Access Compliance Report

Public Rights-of-Way

(Curb Ramps)

Intersection ID: 48985	Main Street: AVONCLIFF_DR	Cross Street: KINGSDOWN_AV	Location: SE
ADA ID: 1BA825160681	Ramp Type: PerpDiag	Initial Pass/Fail: Fail	Overall Compliance: No
Severity Score: 46.25			
Codes/Mitigation Info/Possible Solution		Field Measurements/Component Compliance

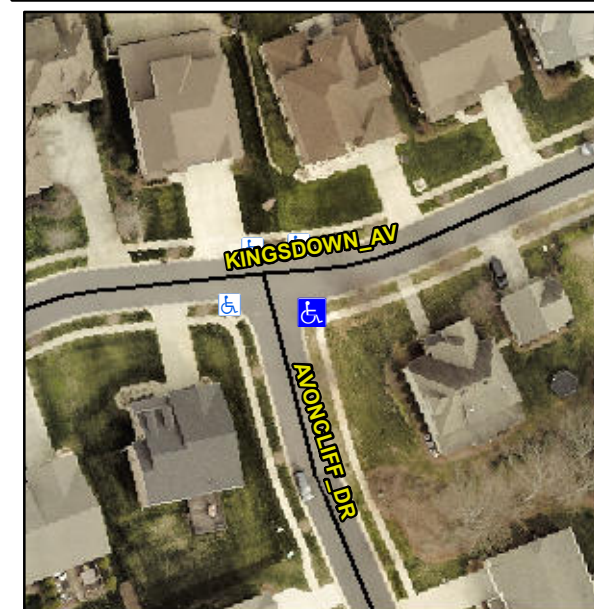
Not Found, R304.5.1, R304.2.2, R304.5.3

Compliance	Description	Data	Compliance	Description	Data
N/A	Ramp Length (in)	74.0	No	Ramp Slope (%)	8.8
No	Ramp Width (in)	42.0	No	Ramp XSlope (%)	9.7
N/A	Flare Type LT	N/A	N/A	Flare Type RT	N/A
N/A	Flare Slope LT (%)	N/A	N/A	Flare Slope RT (%)	N/A
N/A	Flare Traversable LT?	N/A	N/A	Flare Traversable RT?	N/A
N/A	Landing Length (in)	N/A	N/A	DWS Provided?	N/A
N/A	Landing Width (in)	N/A	N/A	DWS Contrast?	N/A
N/A	Landing Slope (%)	N/A	N/A	DWS Length (in)	N/A
N/A	Landing X Slope (%)	N/A	N/A	DWS Full Width?	N/A
N/A	Landing Curb? (Y/N)	N/A	N/A	DWS Offset (in)	N/A
N/A	Shared Landing?	N/A			
N/A	Gutter Ponding?	N/A	N/A	Gutter Slope (%)	N/A
N/A	Gutter Lip Ht (in)	N/A	N/A	Gutter X Slope (%)	N/A
N/A	Painted X Walk1?	No	N/A	Painted X Walk2?	No
	X Walk 1 Direction	To N		X Walk 2 Direction	To W
N/A	X Walk 1 Width (in)	N/A	N/A	X Walk 2 Width (in)	N/A
	X Walk 1 Slope (%)	3.9		X Walk 2 Slope (%)	4.9
	X Walk 1 X Slope (%)	7.9		X Walk 2 X Slope (%)	6.2

Remove & Replace Curb Ramp With Two New Directional Ramps or Equivalent.
